# ADA Curb Ramp New Construction Inspection Form (Perpendicular)

Nw 292nd

23885.56

Nw Fair

## PERPENDICULAR RAMP (PR)

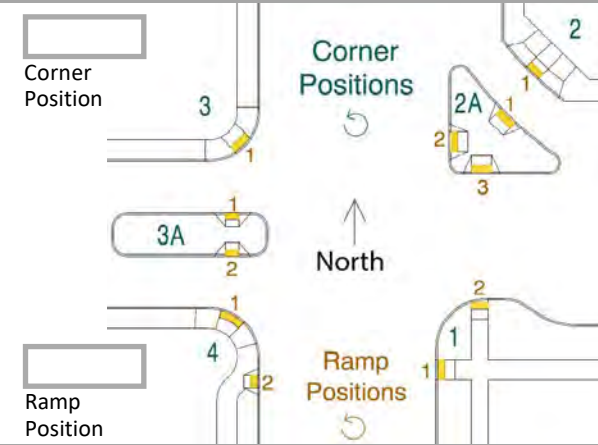
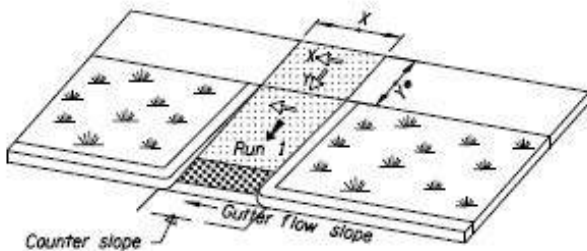
IITD RR1 Fails
